## 2.10 Power Cycle Systems

STD DEP T1 2.10-1 (Figure 2.10.2a and Figure 2.10.9)

### 2.10.2 Condensate Feedwater and Condensate Air Extraction System

Figure 2.10-2a Condensate and Feedwater System

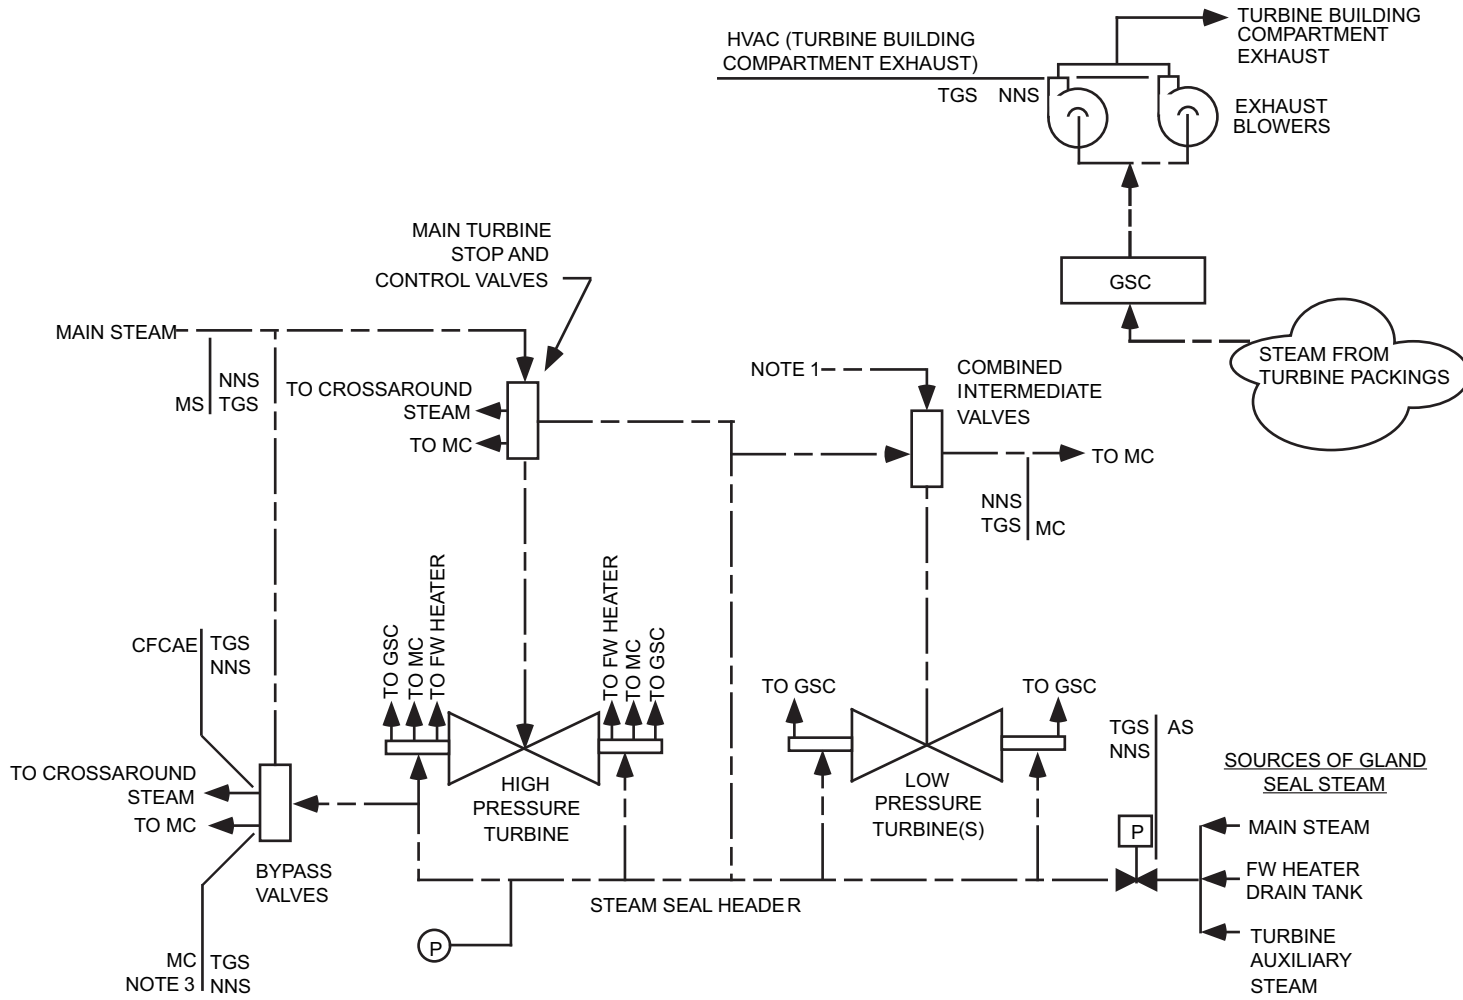
The information in this section of the reference ABWR DCD, including all subsections, tables, and figures, is incorporated by reference with ~~no~~ the following ~~departures or~~ ~~supplements~~.
